Falcon Marketplace (LSC #164350)

**Northeast Roundabout  
Falcon Marketplace  
Preliminary  
Eastonville/Falcon Market Place  
El Paso County**

**Southwest Roundabout  
Falcon Marketplace  
Preliminary  
Woodmen North Frontage Road/Woodmen Right-in  
El Paso County**

Figure 1a

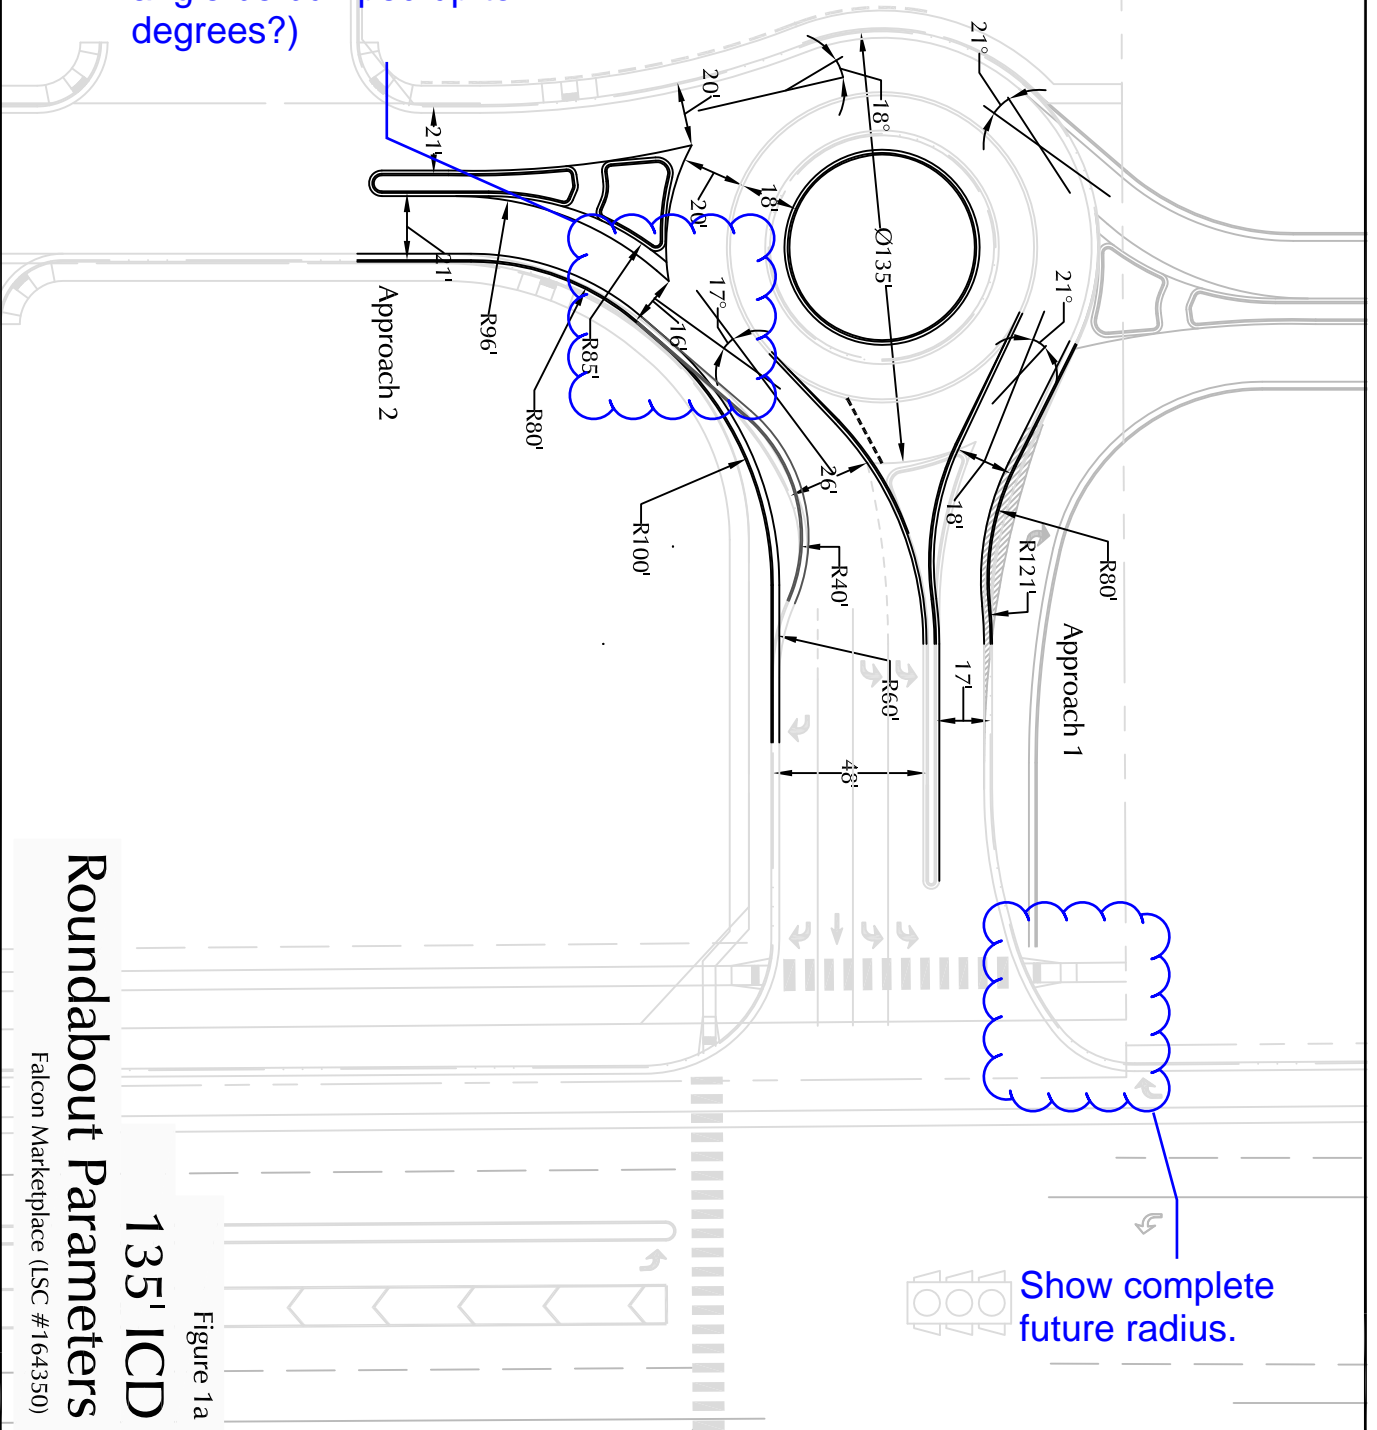
Can the lane be pushed west with drivable apron (see Iorson Ranch Fontaine Blvd. roundabout) to increase the entry angle without affecting fastest path? (Can the entry angle be bumped up to 21 degrees?)

Figure 1

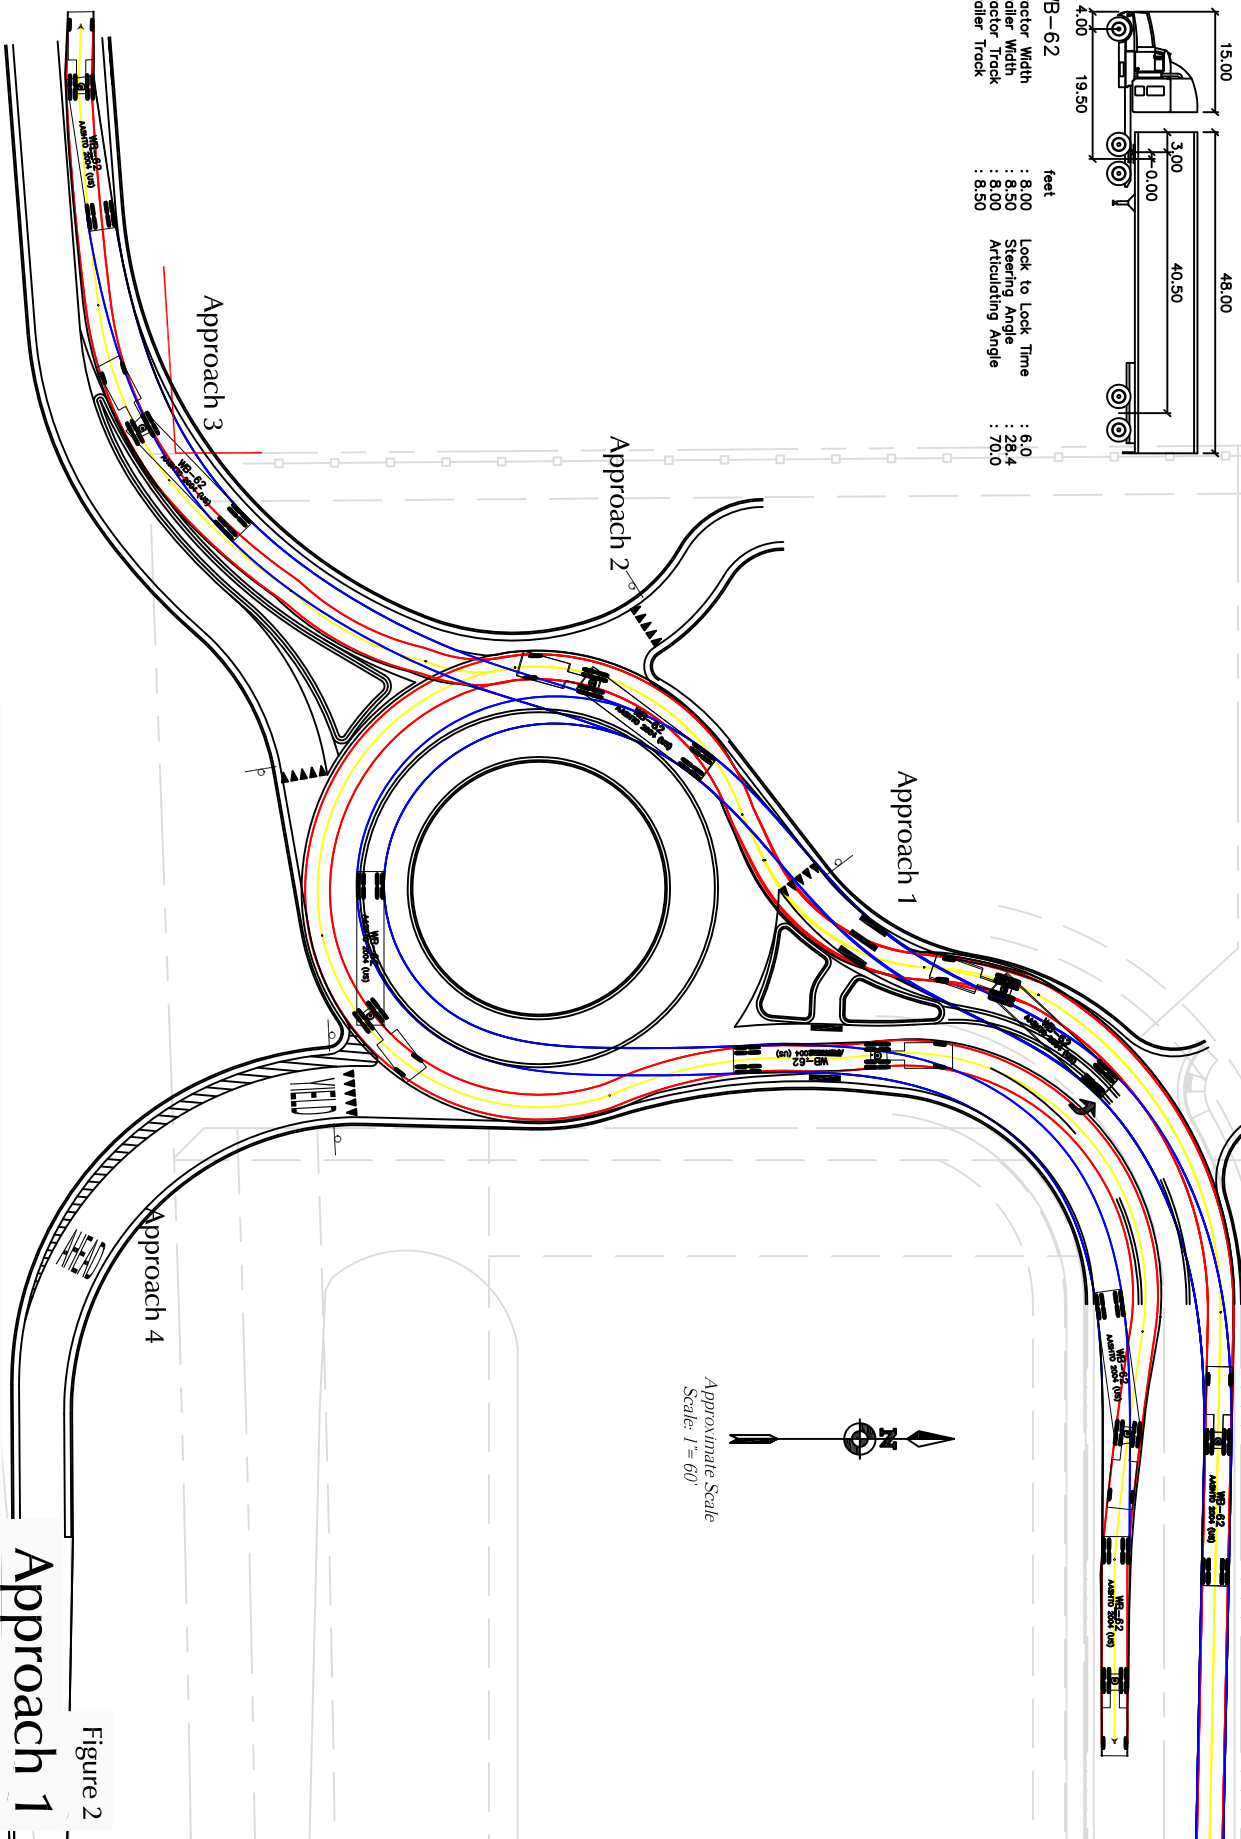
What can be done to increase the entry angles?

Can an apron be placed on this side to increase the entry angle?
